City of Albuquerque

RE: DRAINAGE PLAN FOR 1705 VALDEZ DRIVE, NE
(J-23/D18) ENGINEER'S STAMP DATED MAY 28, 1992

DRAINAGE PLAN
FOR HOUSE LOCATED AT
1705 VALDEZ DRIVE N.E.
ALBUQUERQUE, NEW MEXICO
MAY, 1962

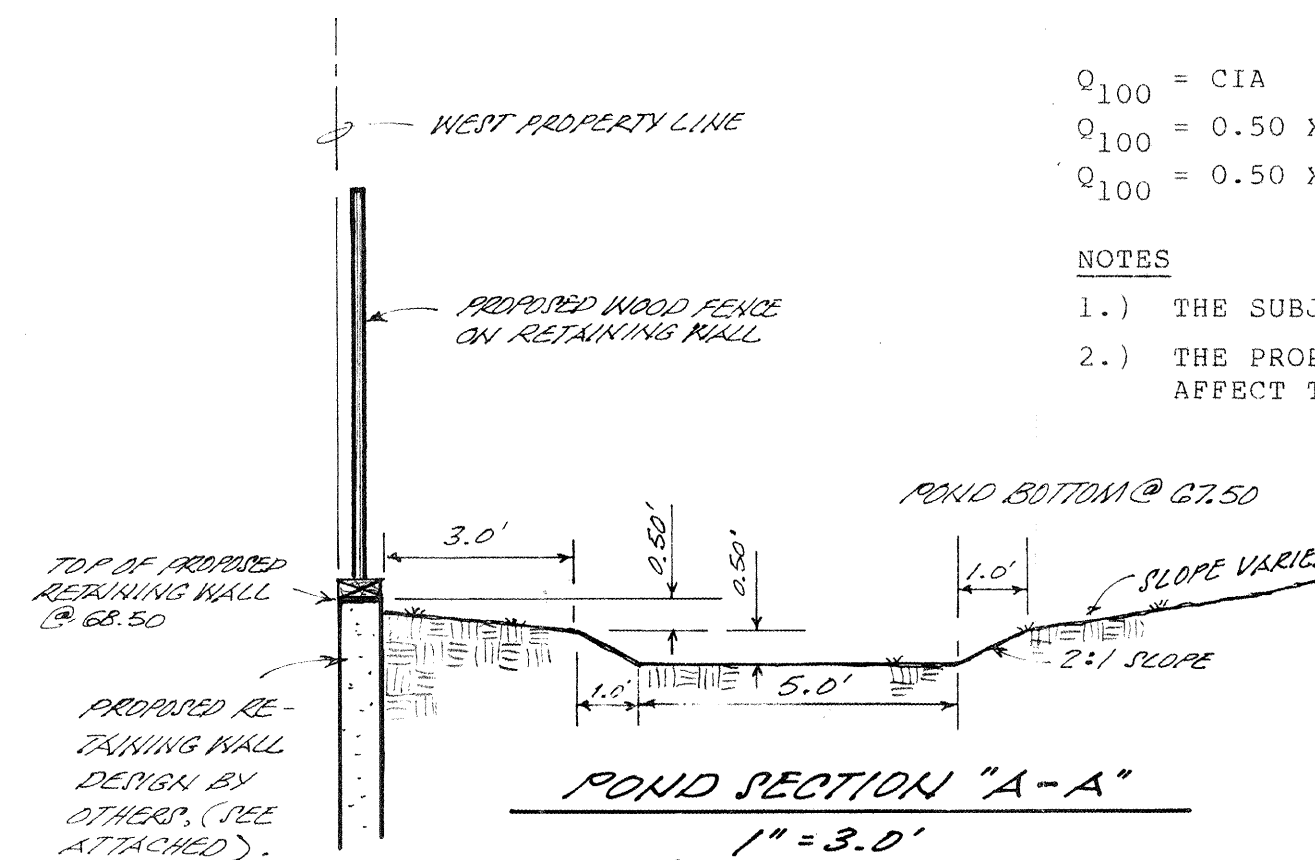
Based on the information provided on your submittal of May 29, 1992, the above referenced plan is approved for Building Permit.

Please be advised that the approval is for the drainage concept and does not include approval for retaining walls or zoning requirements.
